FAQ 17-02 (Final NRC Response)
Palo Verde Unit 3 Scram

Plant: Palo Verde Nuclear Generating Station (PVNGS), Unit 3
Date of Event: 09/19/2016
Submittal Date: 03/23/2017
Licensee Contact: George Andrews Tel/email: 623-393-2219
NRC Contact: Charles Peabody Tel/email: 623-393-3737

IE03, Unplanned Power Changes per 7000 Critical Hours

Figure 1: Reactor Power during the Event

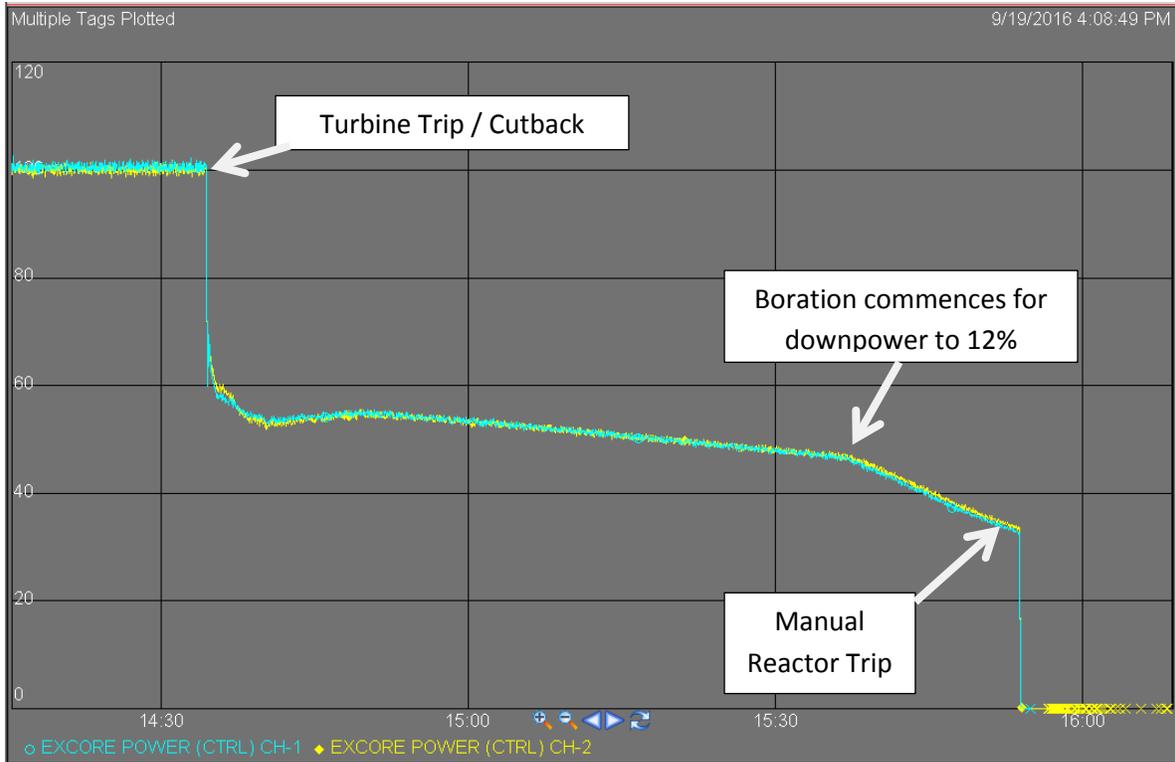
On September 19, 2016, the PVNGS Unit 3 main turbine tripped at 1434 with the unit operating at 100% power. A reactor power cutback occurred automatically, as designed. The control room staff began a power reduction to 12% using abnormal operating procedure 40AO-9ZZ08, “Load Rejection.” Subsequently, based on an assessment of need for troubleshooting and repairs, potential reactivity management challenges at the end of core life, and the uncertainty of cause which might delay the return to full power, the control room staff and plant management made a decision to complete a plant shutdown and place the plant in Mode 3 by tripping the reactor using step 3.24 of 40AO-9ZZ08 from approximately 34% power at 1554 to facilitate repairs. No additional, unexpected plant conditions were occurring that would require a plant shutdown other than the loss of the main turbine. Refer to the Figure 1 for a graphical display of the power changes during the event.

Time	Action
1434	Main turbine trip from 100% power, reactor power cutback reduced power to approximately 53% - operators began briefing and development of game plan for power reduction in accordance with the procedure
1532	Commenced 1300 gallon boration at 31 gallons per minute to reduce power to 12% from approximately 45% power based on reactor engineering game plan
1554	Manual trip of the reactor at approximately 34% power to facilitate troubleshooting and repair of the cause of the main turbine trip

The resident inspectors generally agree with the event synopsis. However, there is an outstanding question of whether the manual trip was required by station procedures. The manual trip is permitted by the abnormal operating procedure, but it was not specifically directed. There is some question as to whether the plant could have been stabilized at 12% to take the turbine off line. Reactor Engineering was advising the operators to continue the down power rather than scram at the time the licensee's management made the decision to manually trip the reactor. If the plant had been stabilized at 12%, then a reactor trip would not have been required and there would be no issue of double counting; it would only register as an unplanned down power. PVNGS chose to manually trip the reactor, which was a conservative decision that was made at the discretion of the licensee, separate from and in no way directly caused by the spurious turbine trip or required by the procedure. Furthermore, had the station been unable to meet a Power Distribution Limit while continuing to down power that would have satisfied direct causation for inclusion as an unplanned scram only. But, as it stands, PVNGS ultimately made a separate decision to manually trip the reactor on less than 72 hours' notice. Therefore, it should be counted as a separate event under the current language of NEI 99-02, Revision 7.

The staff reviewed the procedure used by the licensee for the transient response and eventual plant trip (40AO-9ZZ08 Rev. 31), and discussed the event with the licensee and resident inspectors. The most pertinent parts of NEI 99-02 as pointed out by the licensee involve the definition of unplanned scram and when not to count a downpower that proceeds an unplanned scram. In this event, the initial downpower was caused by an unknown fault on the turbine control system. The decision to trip the reactor was predicated by that initial event. As such, the downpower and scram are subject to the criteria in Section 2.1 of NEI 99-02, Revision 7 (page 17, lines 1-2): "Off-normal conditions that begin with one or more power reductions and end with an unplanned reactor trip are counted in the unplanned reactor scram indicator only."

This event should count as one unplanned scram and no unplanned power changes. No change to NEI 99-02 is required as a result of this FAQ.
